Architect Tech

■ Bulletin #2

Two of the in-ceiling speaker models have extra foam bits in the box.

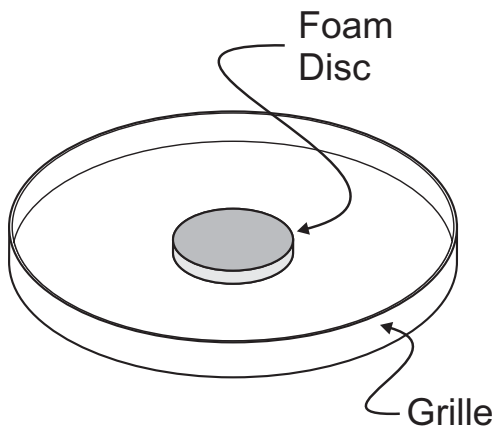
The iC3s from the first production run all have extra foam discs in the box. In addition to the 2.5" diameter disc, there is a 1.5" diameter disc. The 1.5" diameter disc is not necessary and should be discarded by the installer (he can use it as a little tiny Frisbee, or maybe a cat toy). We used to use the 1.5" disc in a discontinued product (CS 6.1). Future production of the iC3 will not have the 1.5" disc making the current batch a limited edition and surly more valuable.

Attenuator

Cat Toy

iC3 -- 1.5" foam disc -- discard, Frisbee or cat toy.

iC1 -- 2.5" foam disc -- discard, Frisbee or cat toy.
